KMR.CDD.MaQ.1922.01

With ref. to his application dated
15th inst. with a plan for the proposed building
on plot No. 32 A & 33 Sub Hb market.
Dr. Mr. Malik Sada, Ahmad is
informed, The building as designed is
badly ventilated.

I beg to inform you that I intend building a four storied
building on plot No. 32A of 33
Survey Sheet No. A-16 situate in Rampart Row
Street, Market Quarter.

PLAN OF PROPOSED HOUSE TO BE BUILT ON S.N^o 33 & 32A. SHEET A-16.

FRONT ELEVATION

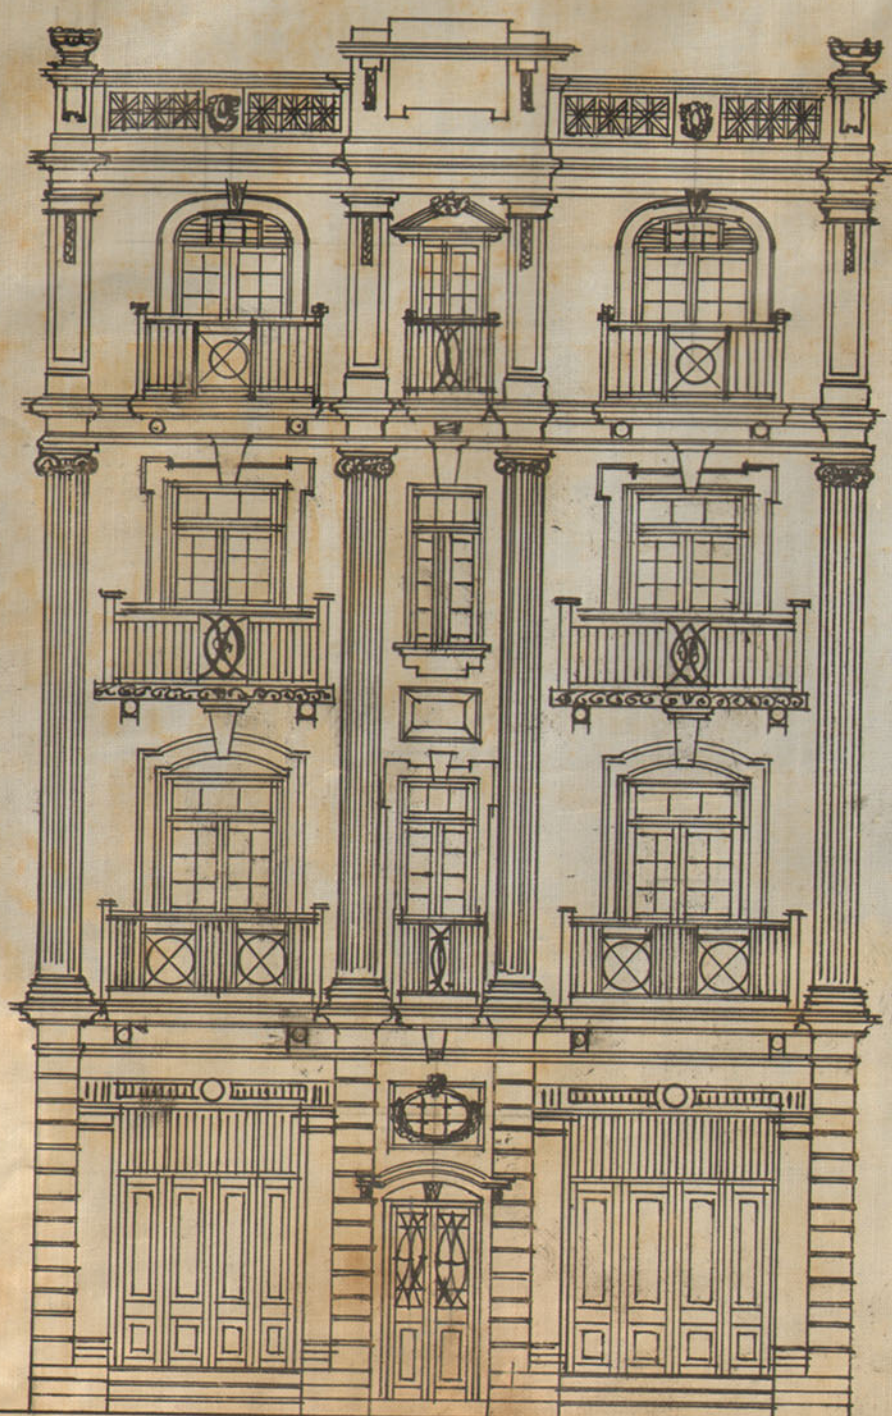
(2) Windows must be provided in each room of shops and in the front wall of building on upper floors.

(2) Windows must be provided in rear walls
of shops and in the front walls of rooms
on upper floors.

GROUND PLAN

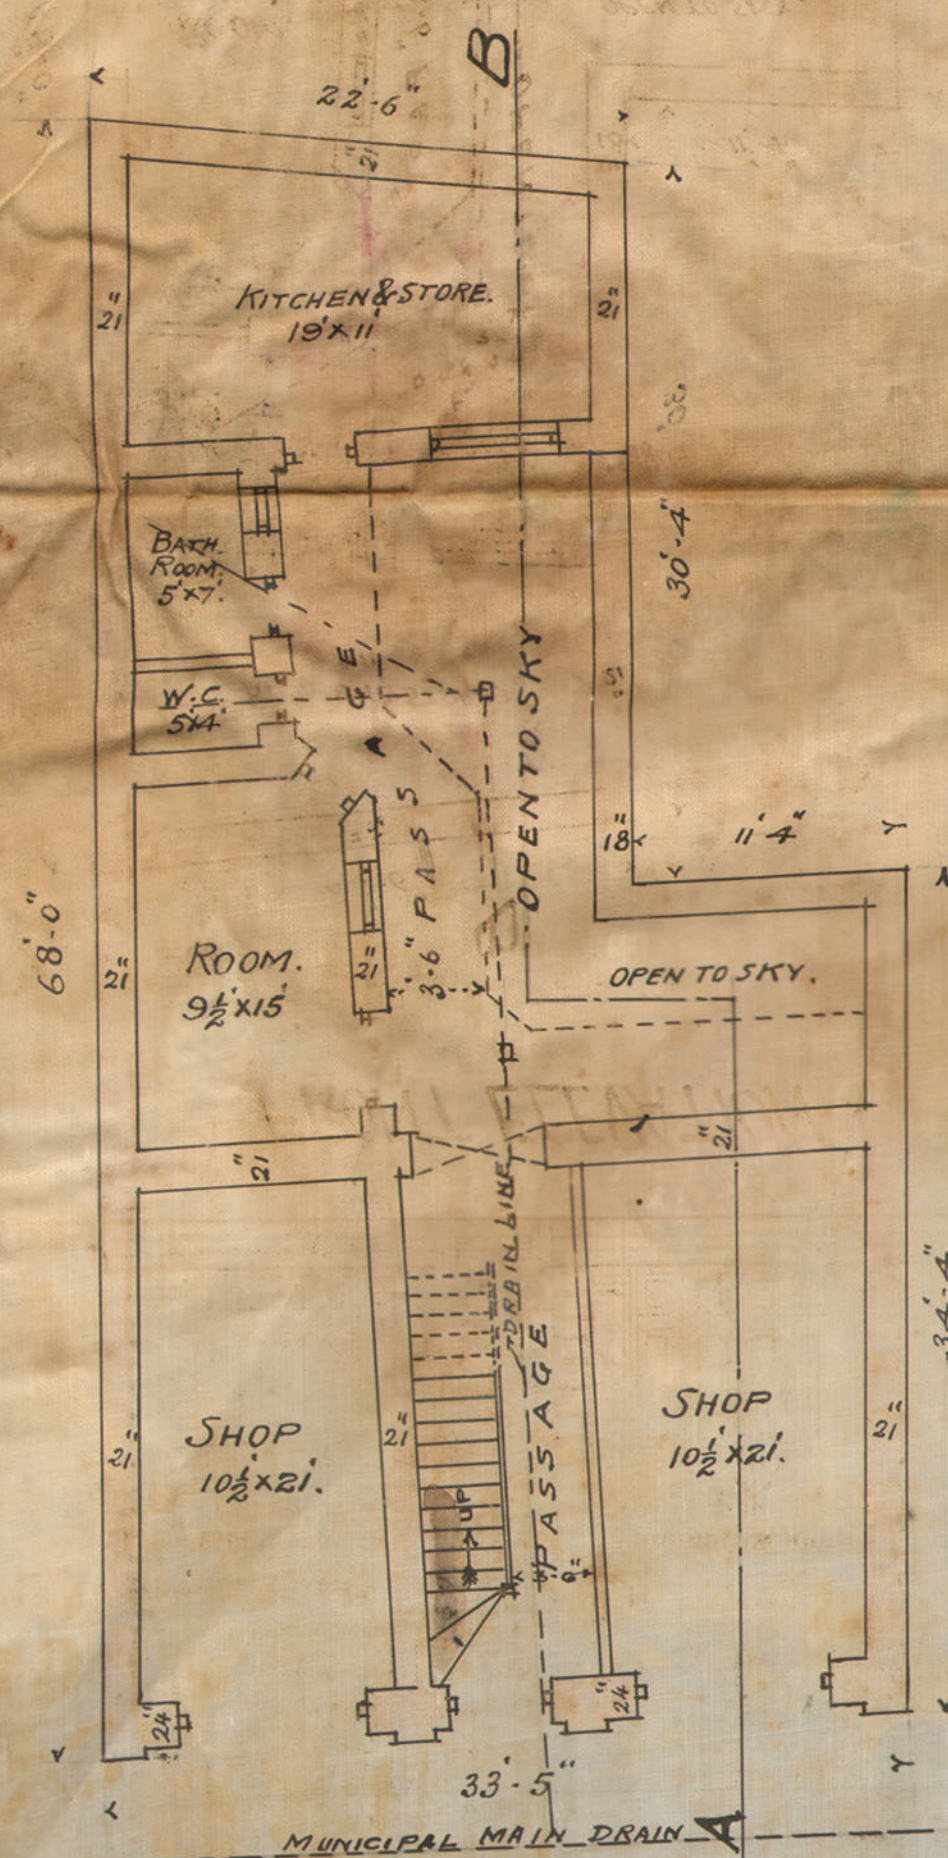
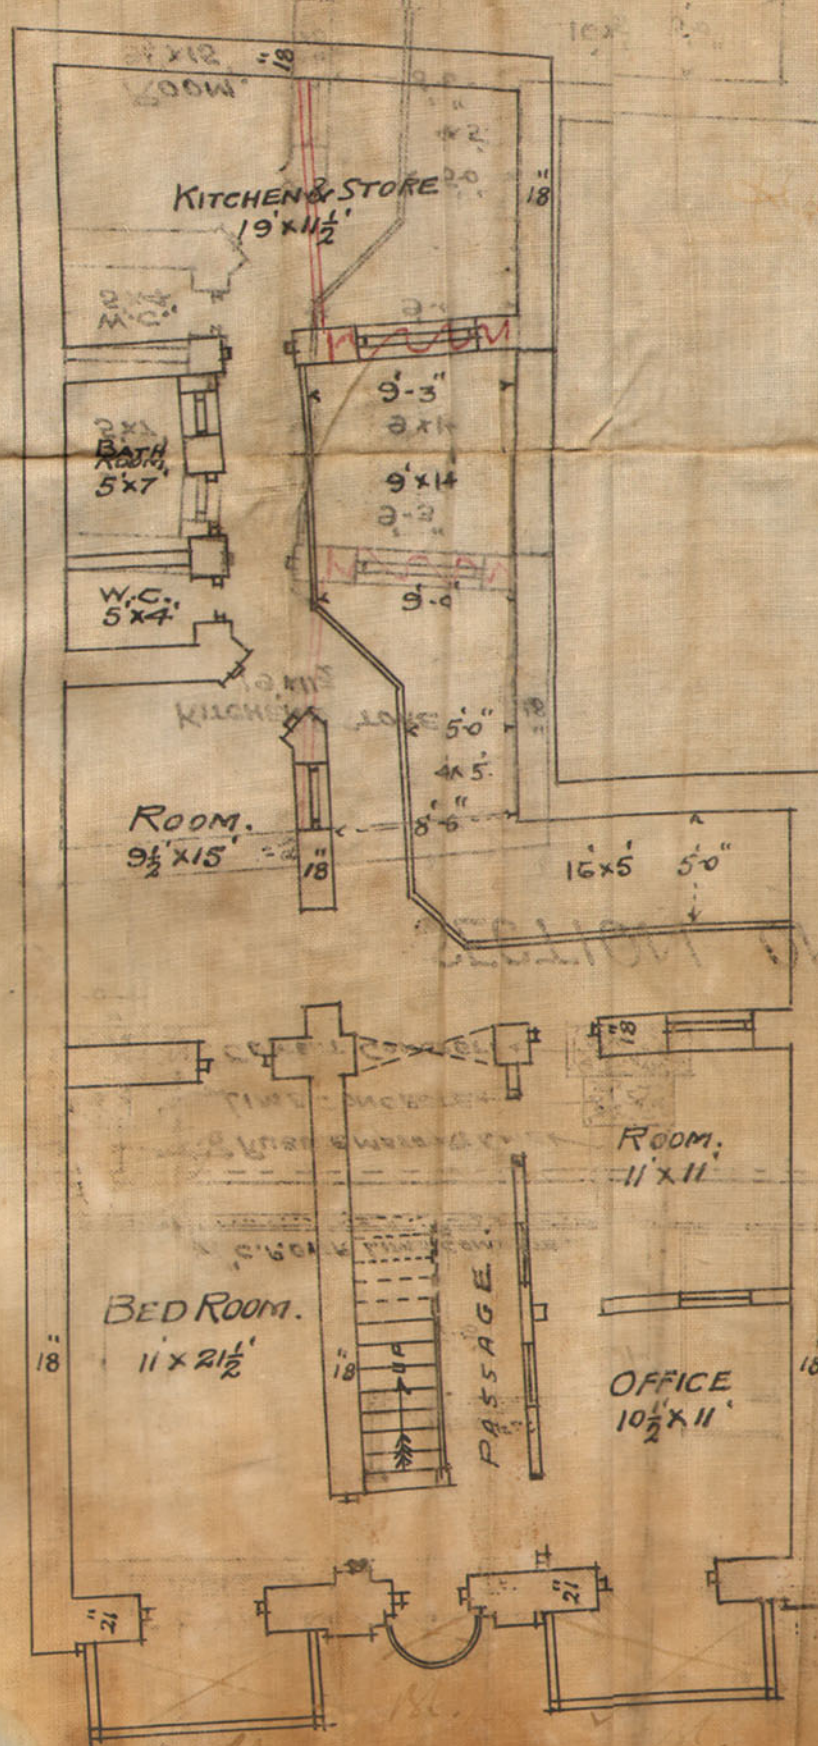
1. The open space must be increased &
windows should be provided in shops & rooms.
2. Balconies must be deleted from plan.
3. He should apply to the C. S. for
amalgamation of the plots.

The distance of 13' 6" should be taken straight to join 10' 6" portion as 2' 6" distance 25 ft. high will obtain no light

(3) The balcony must be detached from the building.

The Aiswell 9' 3" should be taken
straight to join 16x5 portion as 5 ft wide
aiswell 52 ft. high will admit no light.

(3) The balconies must be deleted from the building
plan.

Sd/-
The plan has been
amended as per personal
instructions to the architect.
Request order on the printed
form, to approve the same
